Corrigendum – 3 Dated July 01, 2013 to Tender specification BHEL: PSSR: SCT 1532

Some of the bidders sought clarifications in the tender and the “clarifications issued” are furnished below for your information.

PROJECT: YERMARUS THERMAL POWER STATION
2X800MW

DRAWING NO.: 1-163-10-11374

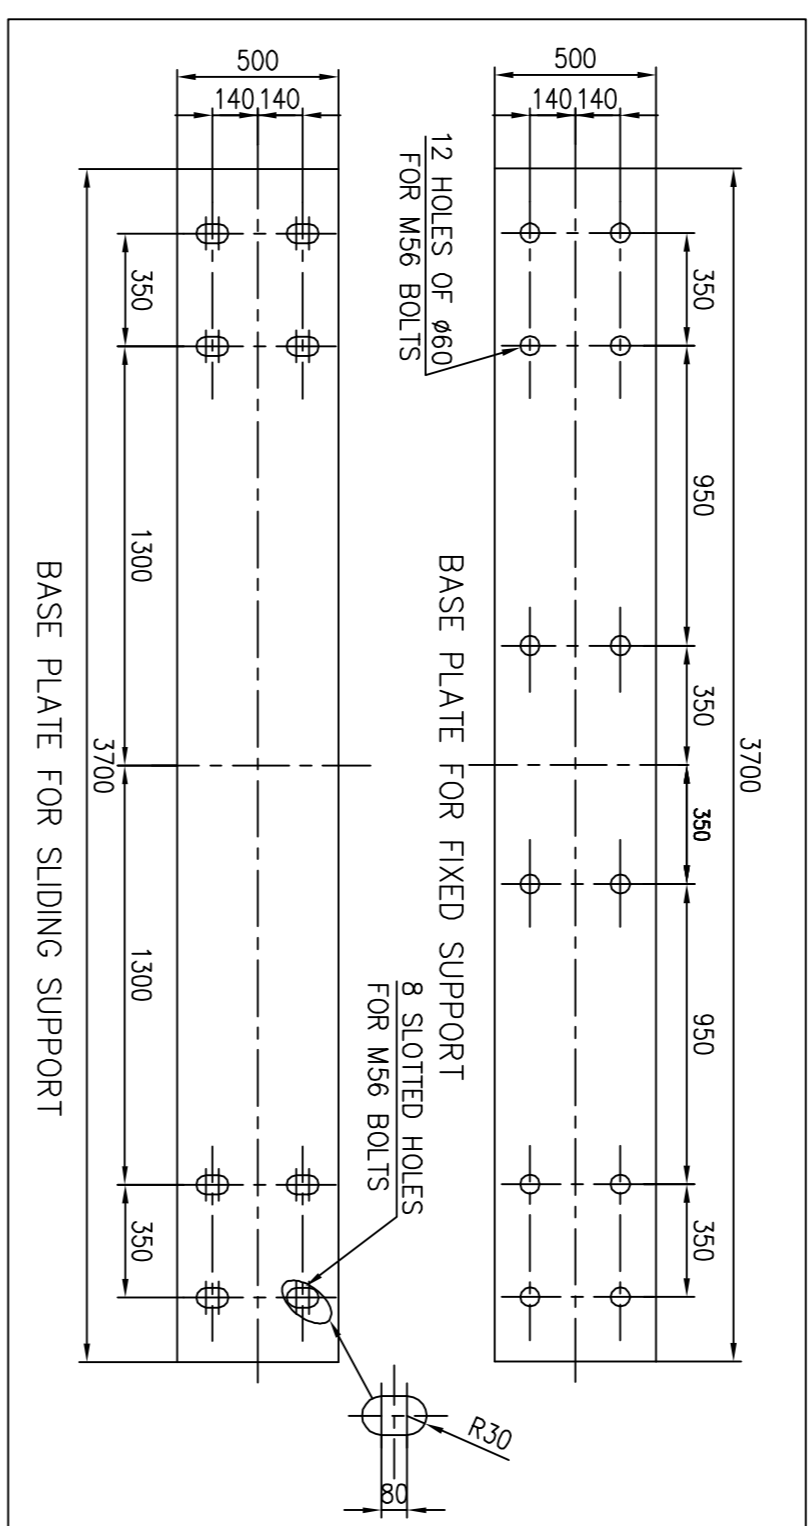
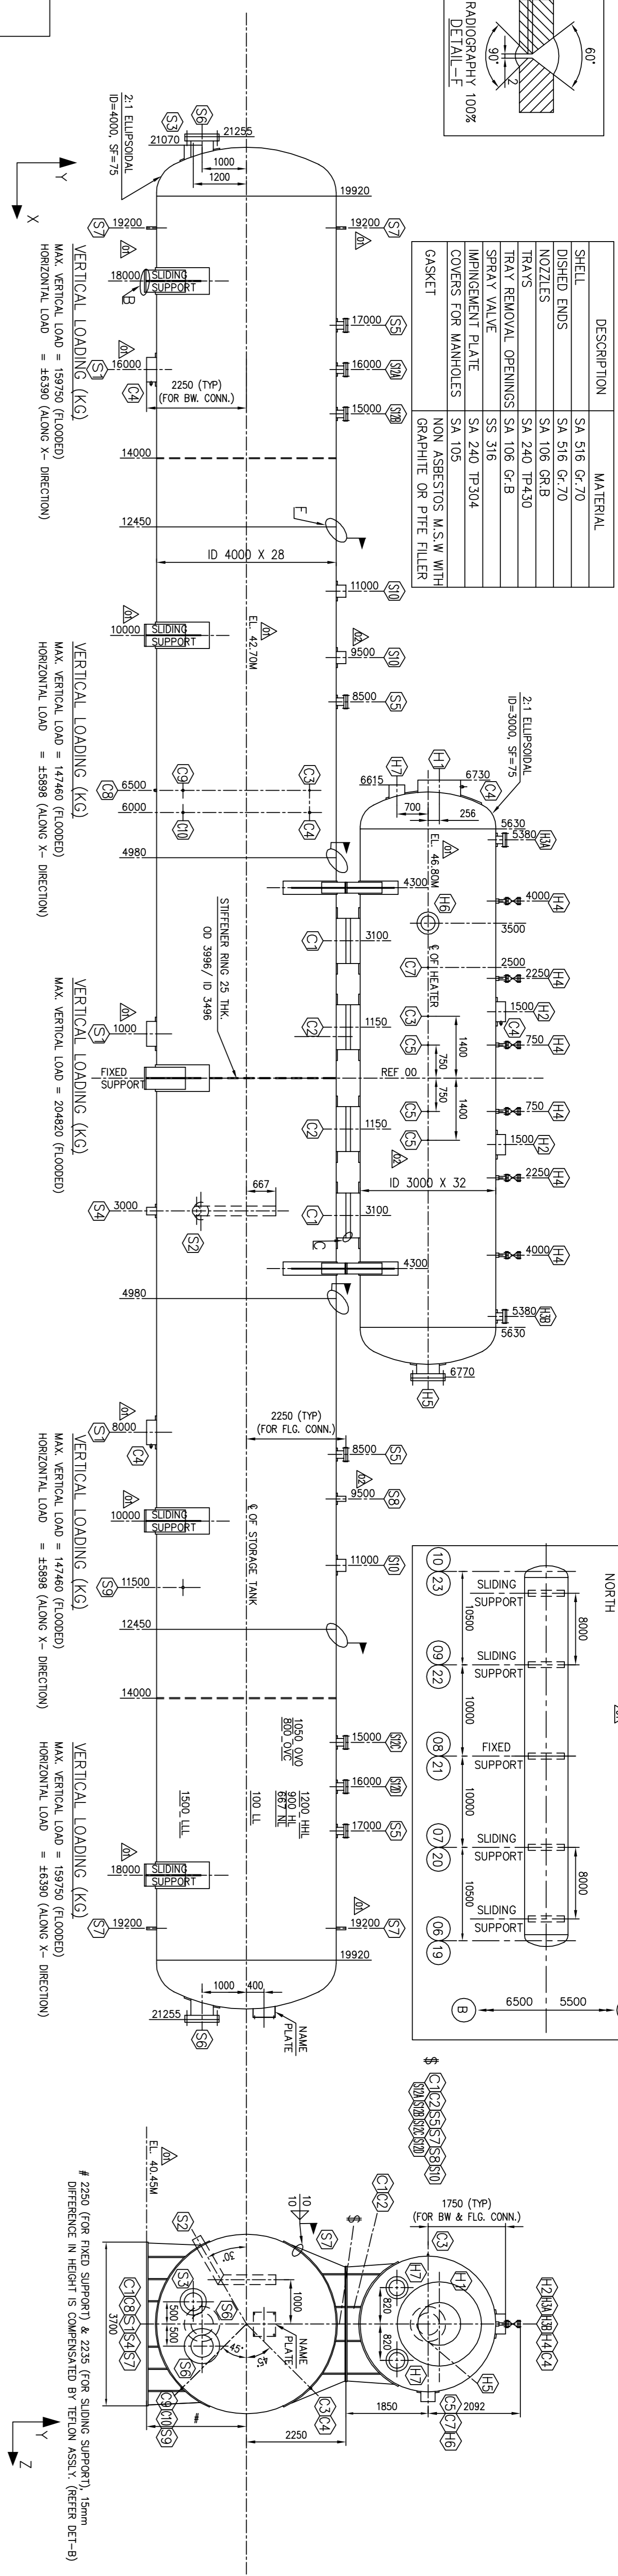
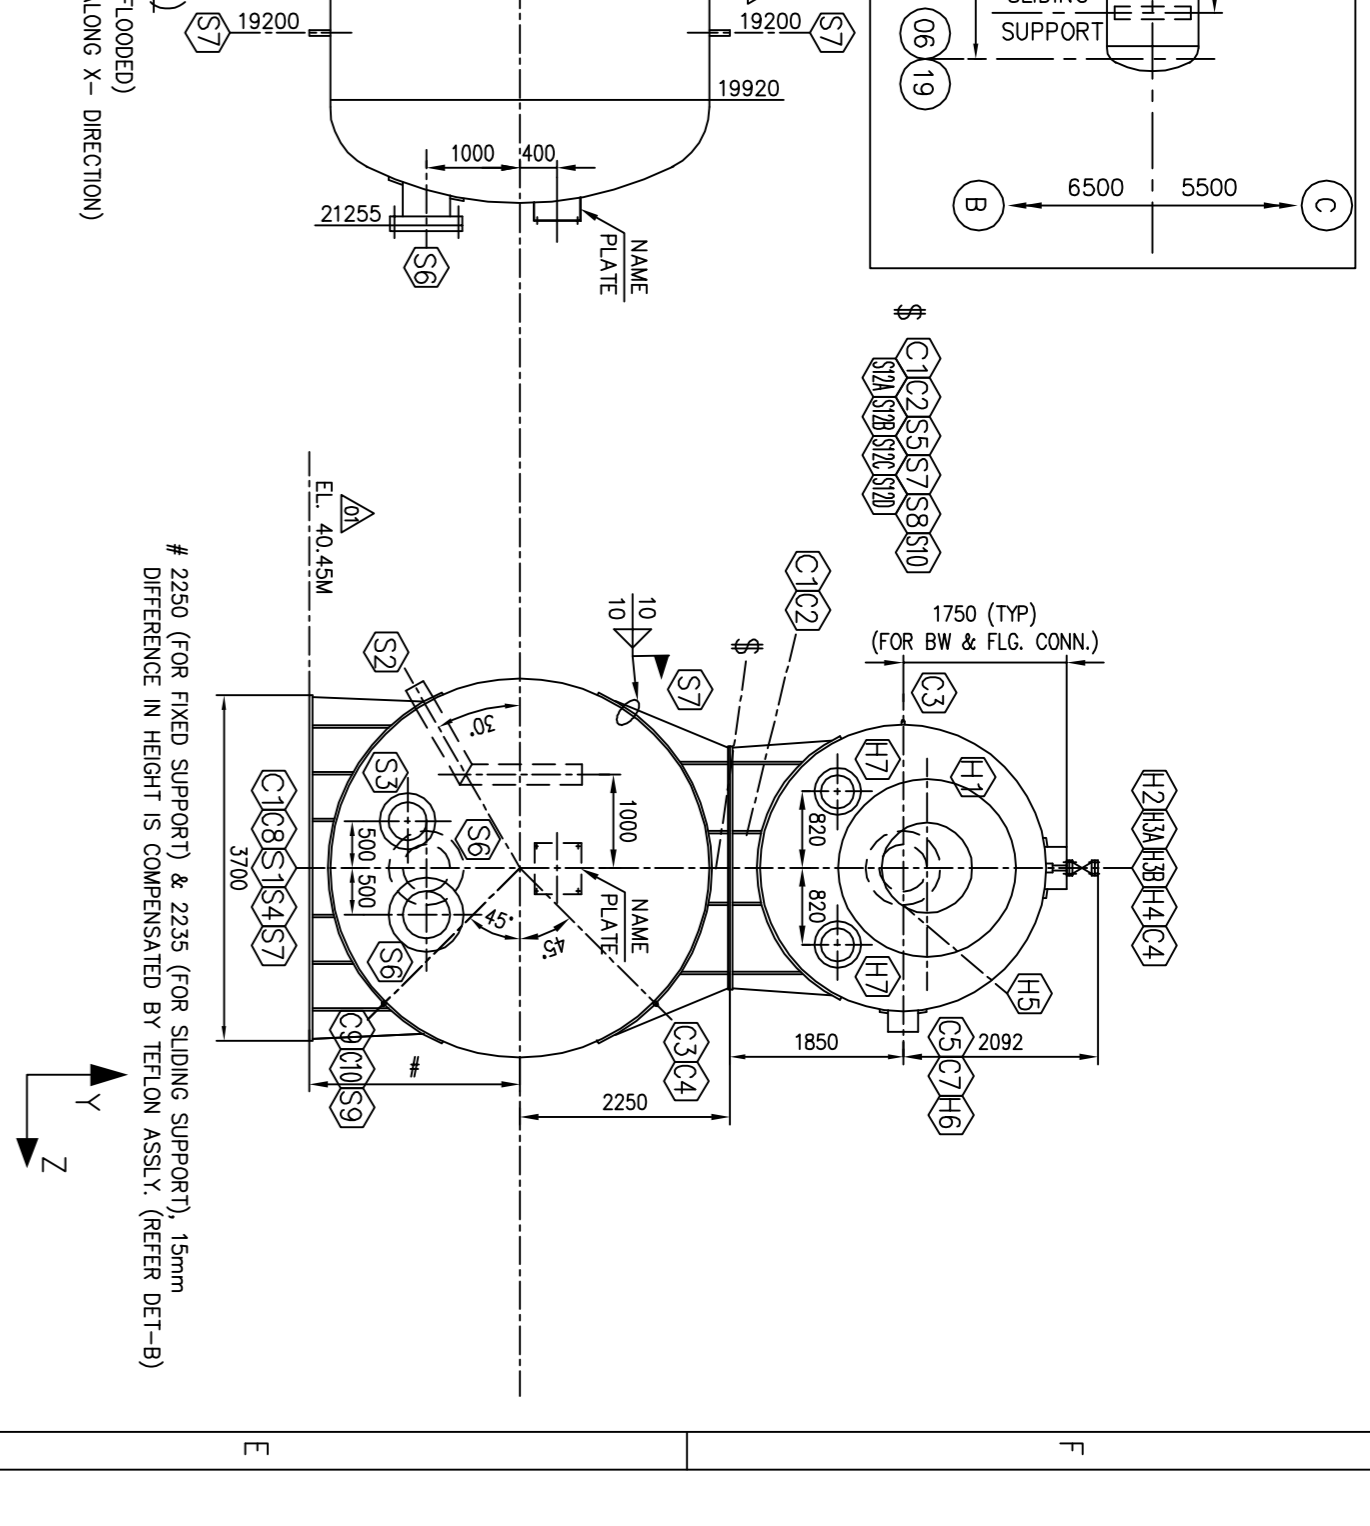
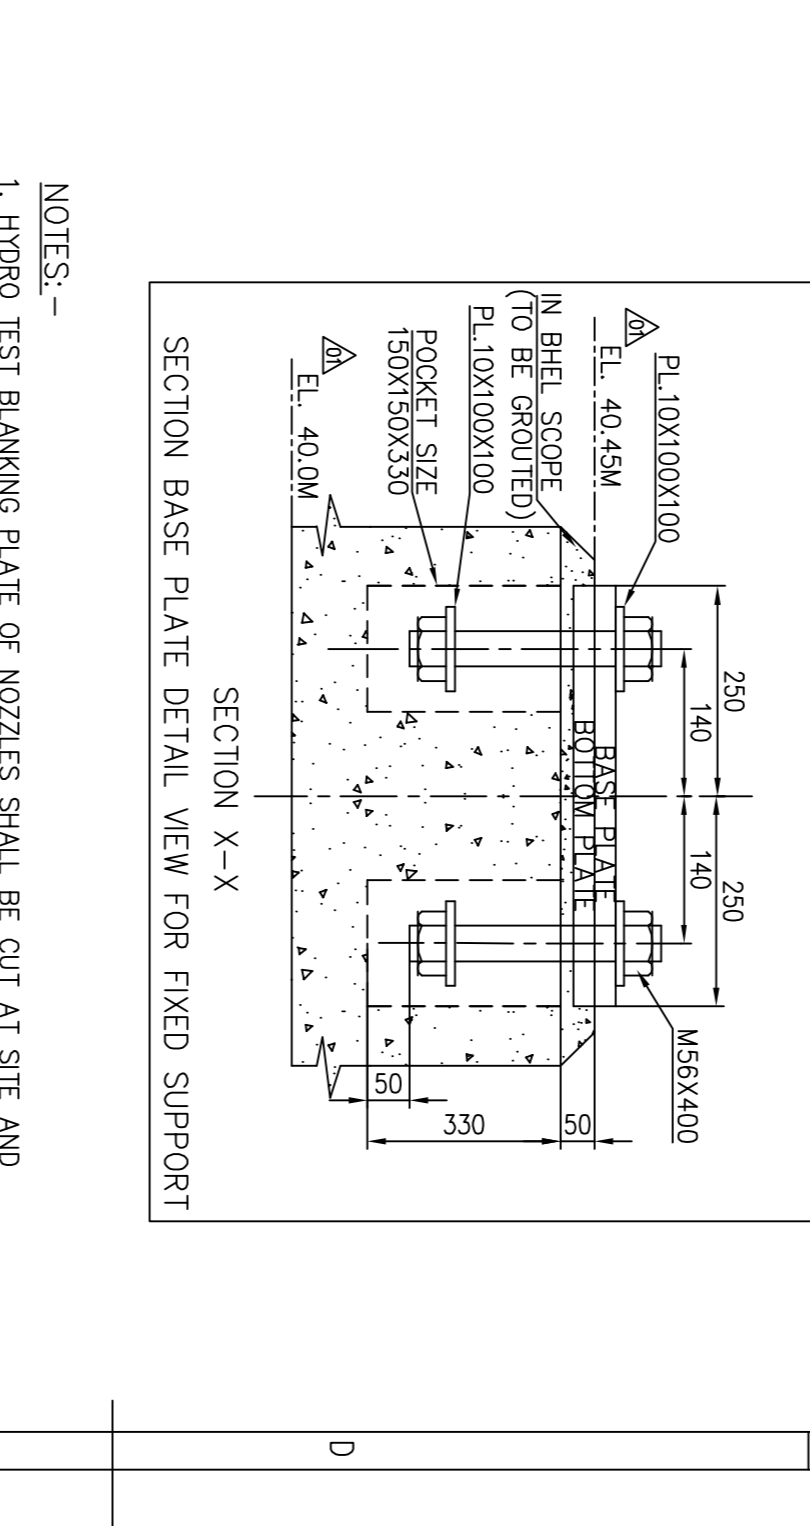
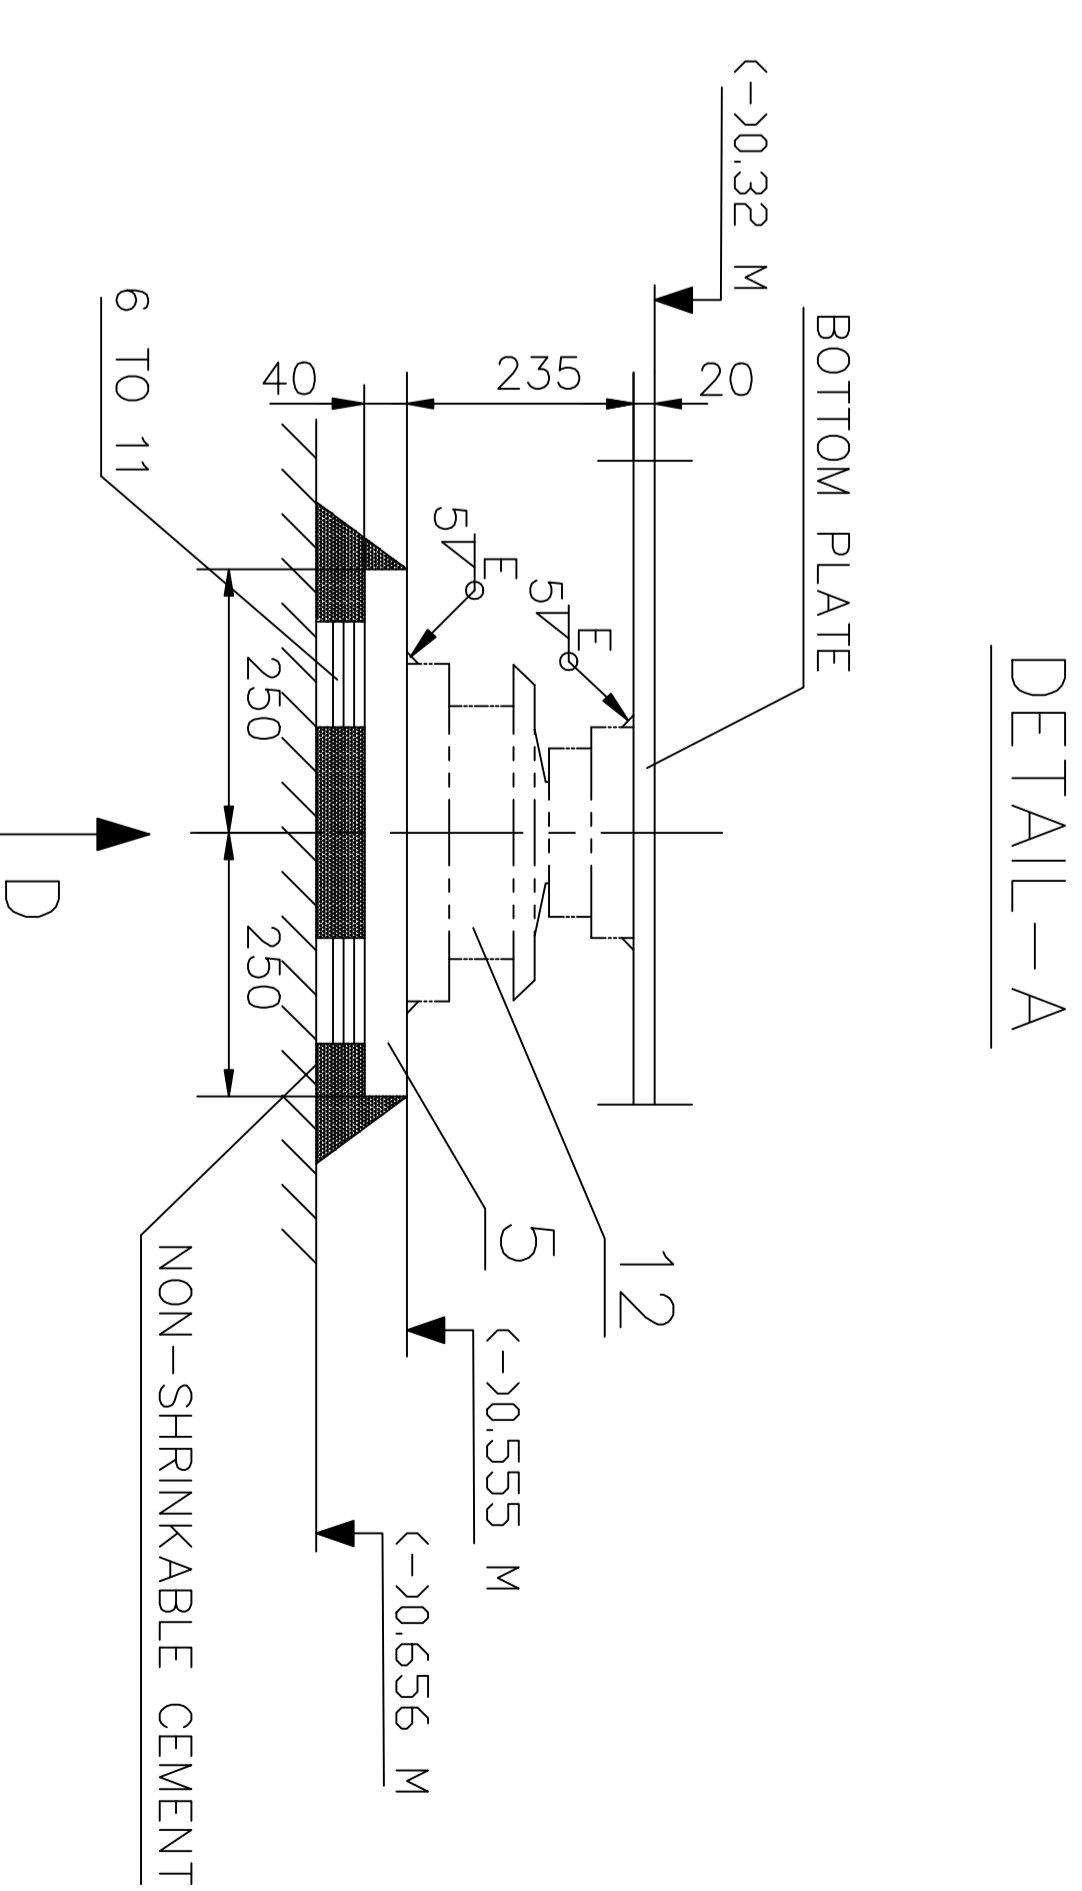
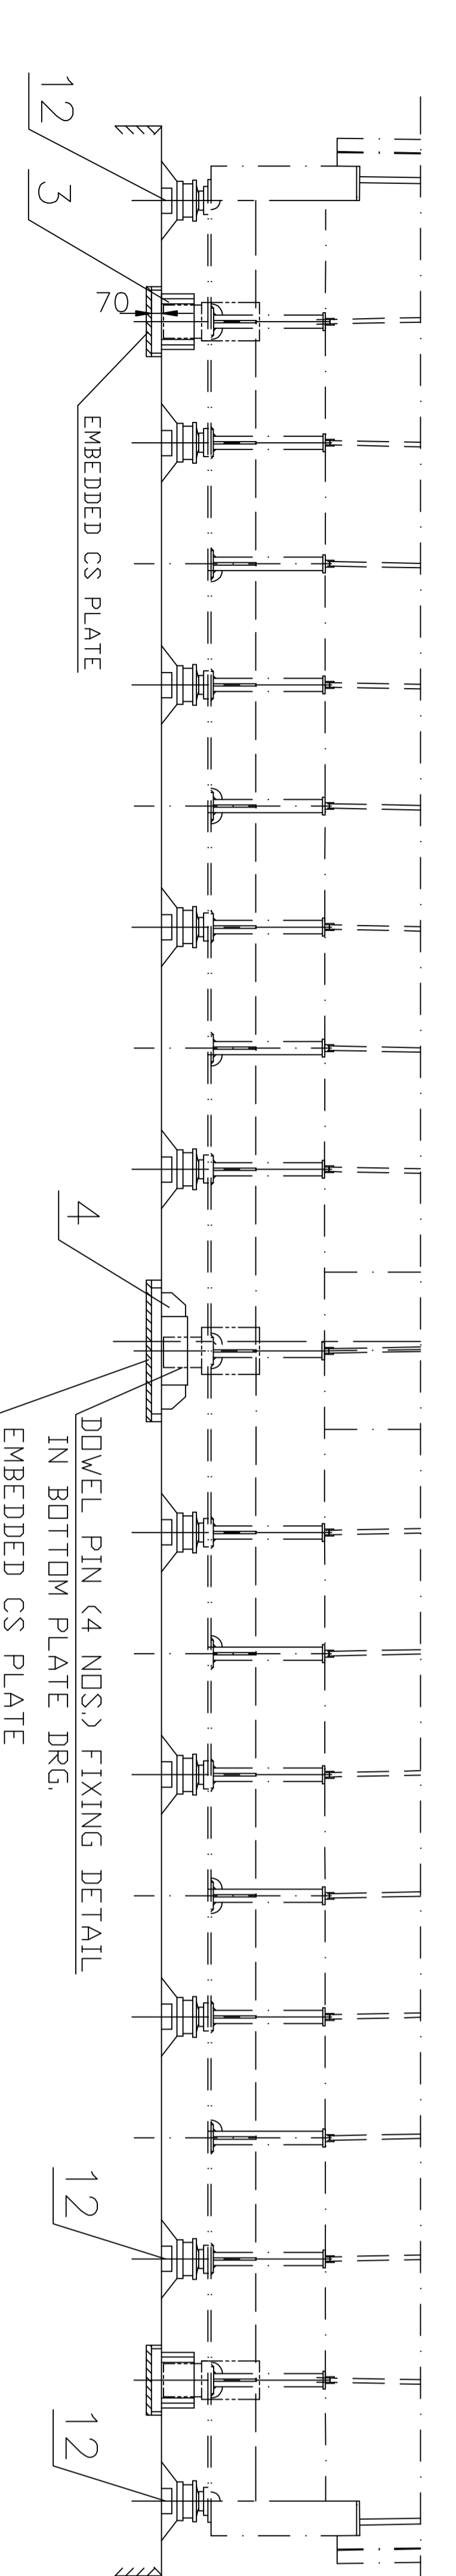
Sl. no	Published in	Existing clause	Bidder's queries	Clarifications issued by BHEL
18.	Techno commercial bid Volume-I Book-I Volume-IA Part-I Chapter- XIII Clause no. 1.13.14	The feed water storage tank will be supplied in three sections with feed pipe, heating steam header, spray nozzles, supports etc., in loose components. These are to be erected, aligned & welded in position. Welding, NDT & heat treatment if required shall be carried out by the contractor within quoted rate.	<p>Please provide Drawing for FST / De-aerator or No of welding joints and thickness of FST and De-aerator assembly works.</p> <p>In this clause it is mentioned that the tank will be supplied in three sections whereas in chapter IX Bill of Quantity it is given as five sections. Please clarify</p>	<p>Drawing-GA of spray cum tray deaerator is enclosed.</p> <p>Feed water storage tank is supplied in five (05) sections.</p>
